**Re: DART+ West Railway Order - Dublin City to Maynooth and M3 Parkway**

We are writing to submit our observations on the DART+ West Electrified Railway Order 2022 (Case reference: NA29S.314232 - <https://www.pleanala.ie/en-ie/case/314232>).

In particular we would like to raise our concerns with the proposals for the development for Leixlip Confey Station, and the associated works at Cope Bridge and on the green space Glendale Estate, Leixlip, Co. Kildare.

**Figure 3-22 Options for Leixlip Confey substation**

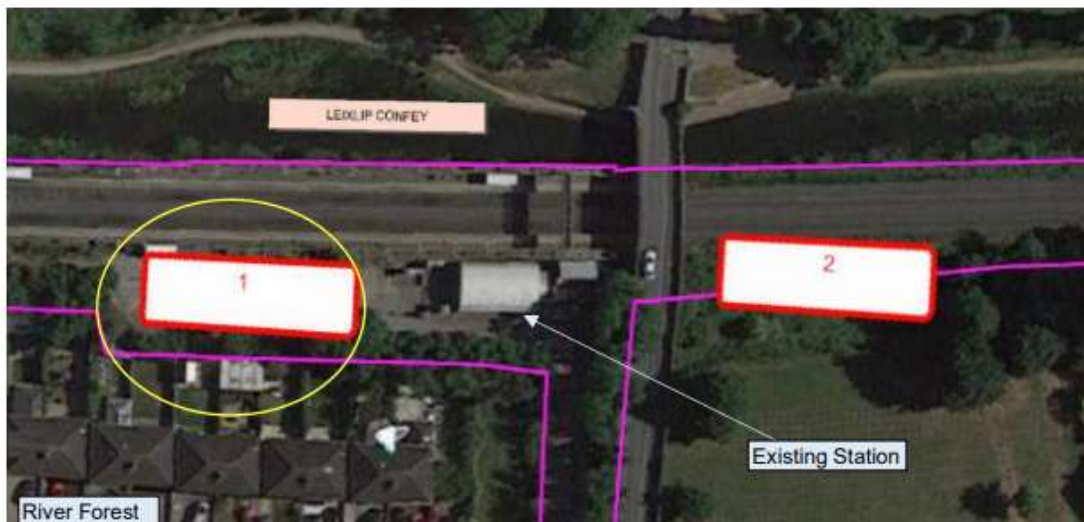
DW.028.P.65(A)). The impact would be greater still as the area directly in front would also be removed. We note that Figure 3-22 'Options for Leixlip Confey substation', in Chapter 3 Alternatives, misleadingly shows the substation far closer to the train line than is actually proposed as per Drawing MAY MDC SET RS12 DR Z 0003 D. In fact, despite the fact that CIÉ does own the land along by the trainline, Option 2 proposes to place the entire substation entirely on private land. We cannot find any reason stated why the substation could not be positioned nearer to the railway line and at least partially on the land owned by CIÉ. The proposed location infringes considerably on the green space and would completely dominate it.

Figures 3-22 shows option 2 as bordering the trainline, whereas in Drawing MAY MDC SET RS12 DR Z 0003 D, there is a considerable gap between the trainline and the proposed location of the substation.

#### Proposed Footbridges

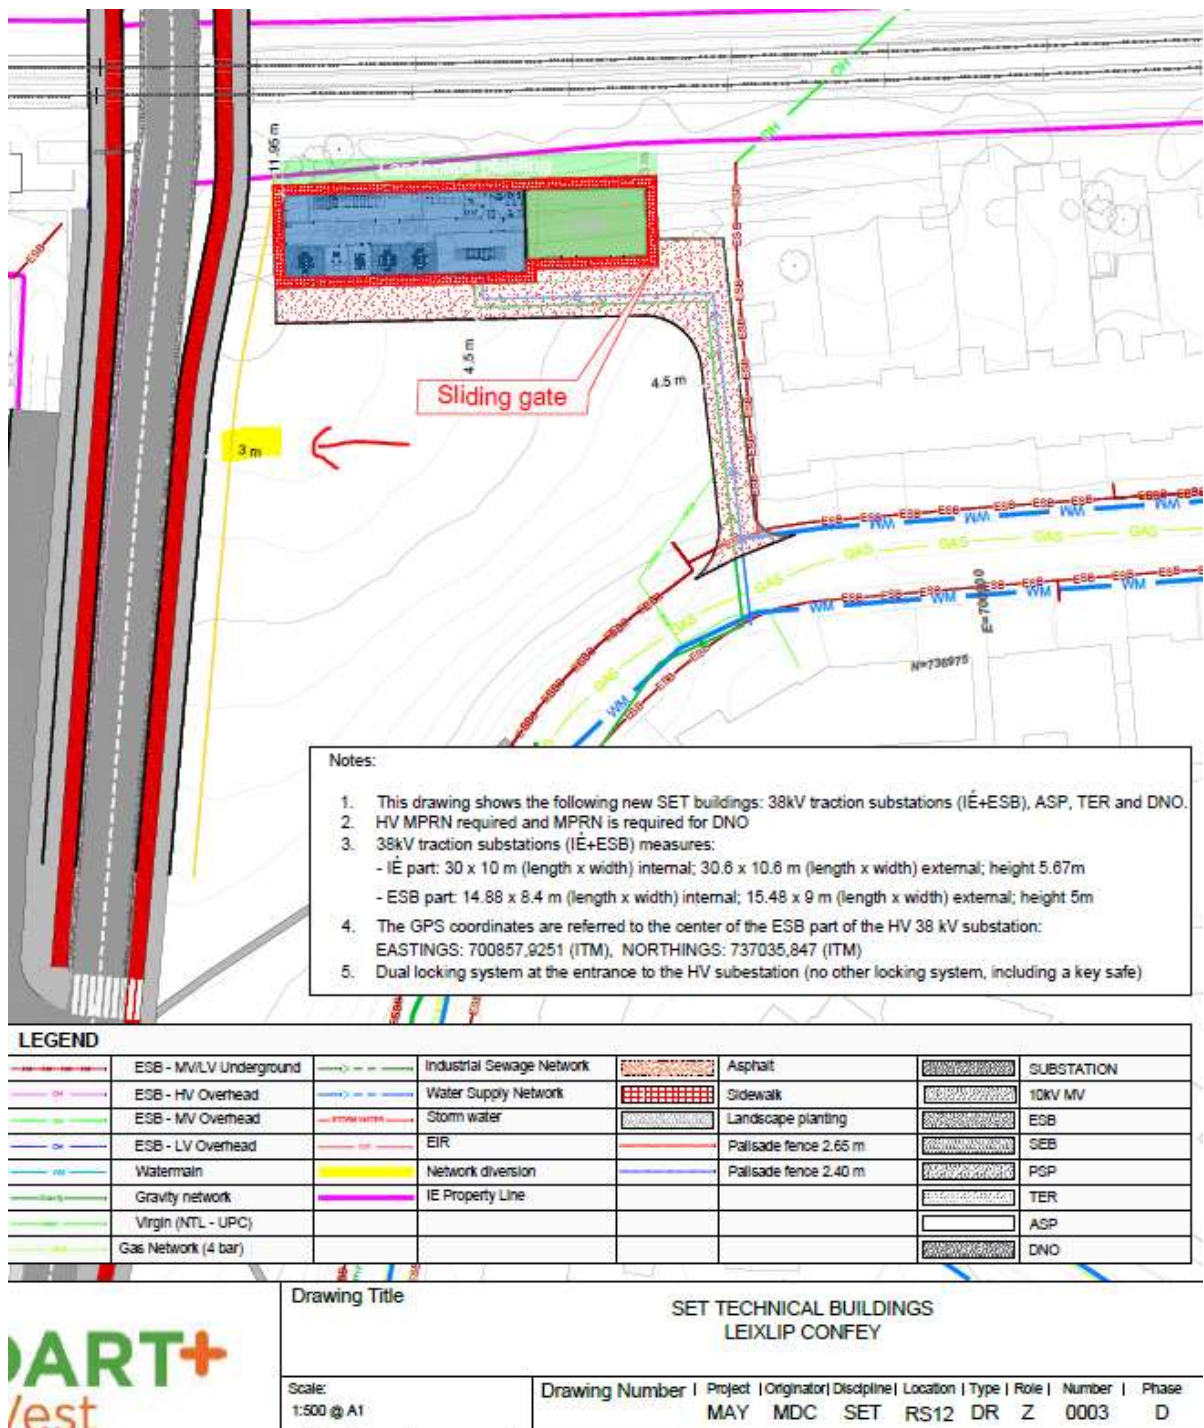
As part of the development at Copy Bridge, and in order to facilitate a return to two-way traffic flow, it is proposed to construct two new footbridges – one each on the east and west side of Cope Bridge. We understand that such development would improve safety for pedestrians and cyclists by providing separate facilities to the road. However, we question the need for two bridges, with each facilitating both pedestrians and cyclists.

- Omission of the proposed east footbridge in its entirety. The proposed west footbridge would provide ample room for the volume of pedestrians and cyclists that would be traversing the canal and trainline at any point in time, given that 2m is provided for each.
- Reduction in each of the east and west footbridges so that one is dedicated to pedestrians and the other dedicated to cyclists, thereby providing further safety for each by provided full and complete separation.

The proposed east footbridge is over 4m in width. It is proposed to build it over the greenspace at Glendale Estate. However rather than constructing it in the traditional manner on pillars with free area underneath it, the proposal includes a large embankment and retaining wall. The area of this embankment is unclear, and from Drawing MAY MDC SET RS12 DR Z 0003 D, we had assumed that the yellow line with '3m' beside it was showing the size of the embankment, resulting in over 7m of greenspace removed along the full length of the existing wall, as highlighted below:

However, we believe that this is in fact not the case and that the embankment would take up considerably further space based on Drawing MAY MDC STR RS12 DR C 0003 D, which shows the green embankment area far wider at times than the footbridge and therefore wider than 4m. In fact, it appears that 3m is in fact the minimum and that the width of the embankment could be over 1.5 times the width of the footbridge at its widest. This would therefore result in the greenspace being reduced in width by over 10m at times.

### Construction Compound

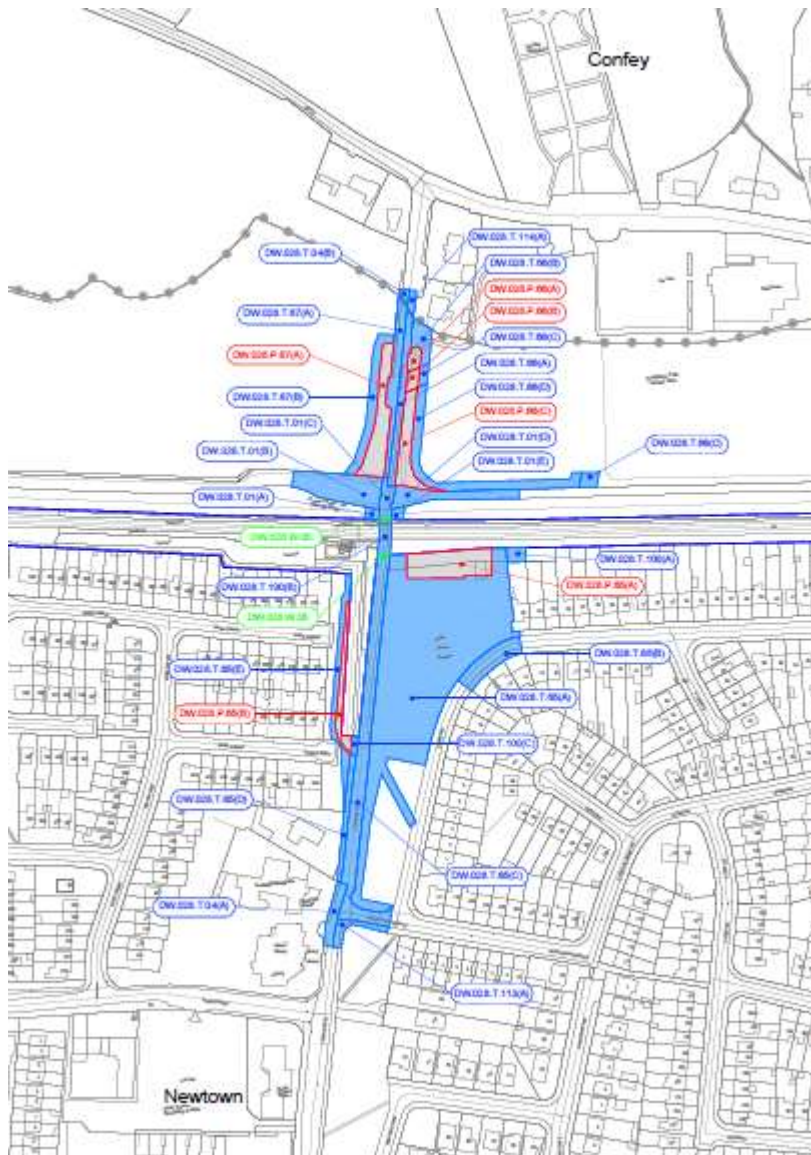
The proposal includes the majority of the greenspace at Glendale Estate being taken over as a construction compound. This is highly unsuitable in a residential area, and alternatives should be identified.

The proposal as shown in Book 2 Property Plans Part 2 shows the majority of the greenspace at Glendale Estate being taken into temporary possession:

This would effectively render the entire greenspace unusable for we presume a number of years. There would be long-term damage to the biodiversity, some of which may be irreplaceable. There would be increased pollution, noise and disturbance for residents.

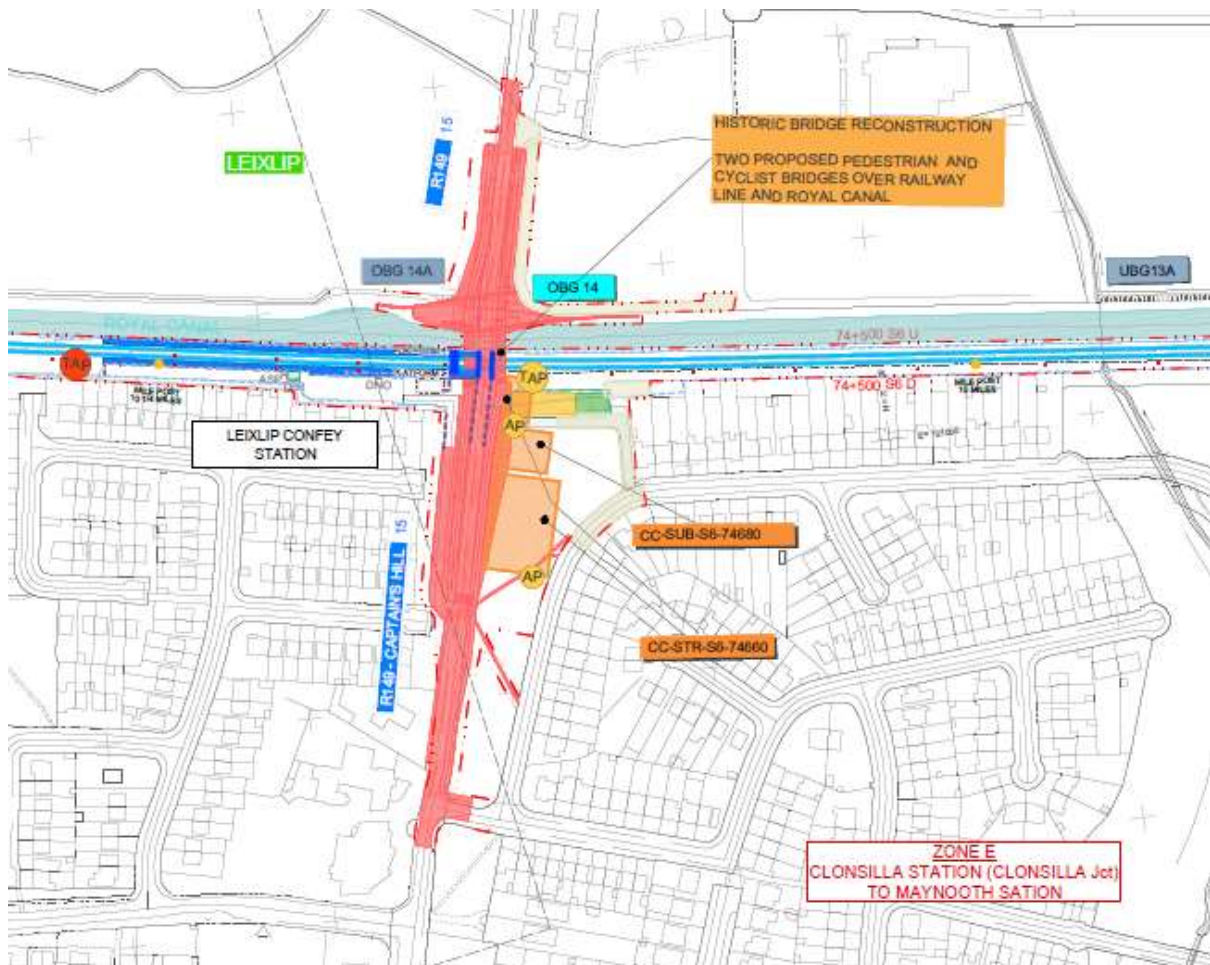
We also note that there is inconsistency in the amount of greenspace proposed to be used for the construction compound with a far larger area shown in blue in the above drawing (from Book 2 Property Plans Part 2), than is shown in PROPERTY PLAN NO: DW.028 from Appendix B Proposed Development Drawings which shows the area in orange as the construction compound. Both however impact considerably on the greenspace and block at least one if not both of the access paths which the residents use to access the train station, Confey GAA Club and Confey graveyard.

Either would be materially damaging to the area and the residents and both proposals contradict Policy OS 1 of the Leixlip LAP which states that “It is the policy of the Council to provide for a hierarchy of high quality multi-functional public open spaces within Leixlip, and **to preserve and protect such spaces** through the appropriate zoning of lands”, as well as not meeting the criteria stated in Section 5.1, of the Non-Technical Summary to “Avoid, mitigate and if not possible reduce the adverse effects on communities during the construction of the project.” The proposed location and extensive scale of the construction compound seek to attain maximum adverse effect on us and other residents.

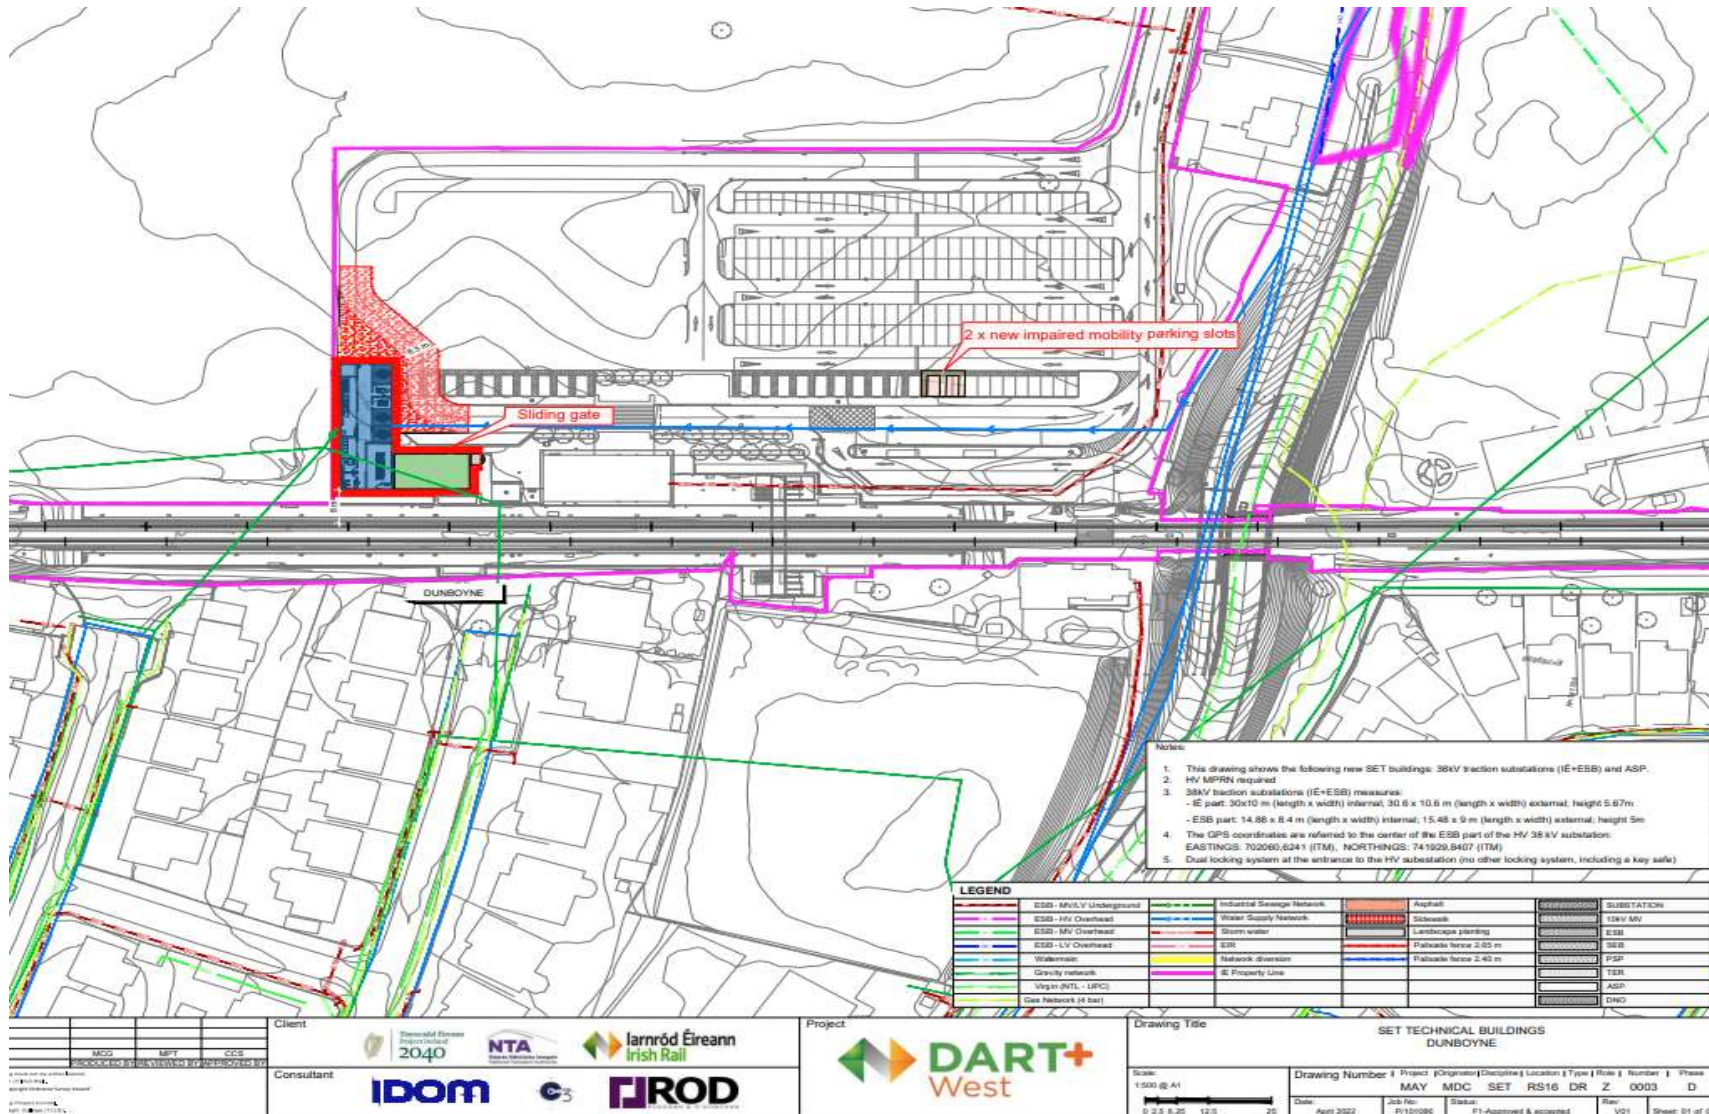
- could the ESB section be at a 90-degree angle to the substation as per the proposed substation at Dunboyne station (ref. Drawing MAY MDC SET RS16 DR Z 0003 D in Appendix I)?

- could the platform also be used as an access point for the substation as is planned at Ashtown station (ref. MAY MDC SET ROUT DR Z 0003 D in Appendix I). As per our drawing in the Annex, we don't believe this is required, but it would provide more flexibility in providing access around the perimeter of the substation.

- why is the pathway required around all sides of the substation proposed at Leixlip Confey? We cannot find any reason stated for this, although it is one of the reasons stated for needing to move the substation from Option 1 location to Option 2 location. We note that the proposed substation in Maynooth has the pathway on three sides only (ref. Drawing MAY MDC SET RS14 DR Z 0003 D in Appendix I). Can the same approach not be taken at Leixlip Confey substation?

Extract from MAY MDC SET ROUT DR Z 0003 D which shows access to substation from the platform which could also be done at Leixlip Confey station.

Extract from MAY MDC SET RS16 DR Z 0003 D which shows an L-shaped substation which could also be considered for Leixlip Confeys station.

Extract from MAY MDC SET RS14 DR Z 0003 D which shows that the path is not required on all 4 sides as was identified as a requirement for the substation at Leixlip Confey station.
